Recall Campaign Bulletin

Campaign No. 2019100011, October 2019

SUBJECT: Model GLE-Class (167 platform) and GLS-Class (X167 platform)

Check window divider on right and left rear doors, Rework if necessary.

Figure 1 Figure 2

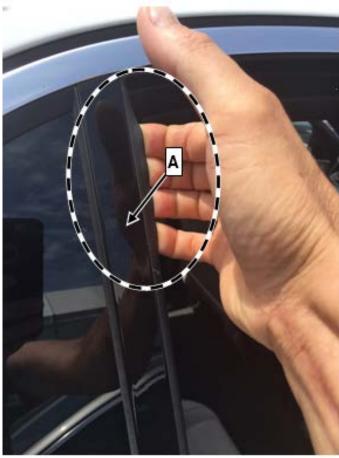
- 1. Lower side window on right and left rear door.
- 2. Check window divider (A, figure 1) on right and left for tight seating.

To do so, grasp the window divider in the upper area by hand (figure 1) and support with the thumb on the fixed window (figure 2). After this, carefully pull the window divider to the outside with minor force.

The window divider should not detach due to the minor force. Ensure that there is at least a 1mm clearance between the chrome trim strip (**B**, Figure 2) and window divider (**A**, Figure 2), and that the window divider does not jam under the chrome trim strip of the window frame (**B**). If the window divider jams under the chrome strip, the test results in a false positive.

- a. Window divider (A) detaches due to slight tractive force: Carry out work procedure.
- b. Window divider (A) does not loosen due to slight tractive force: End measure.
- The inspection scope findings must be recorded in writing on the work order

Figure 3

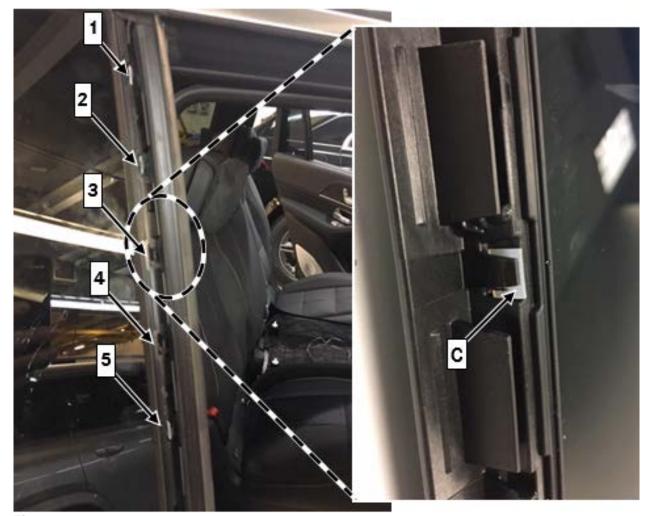
- 1. Insert spacers (C, figure 3) into clips 1 to 5 (counted from above).
 - Pay attention to the correct position of the spacers. Ensure that the spacer is fully inserted.
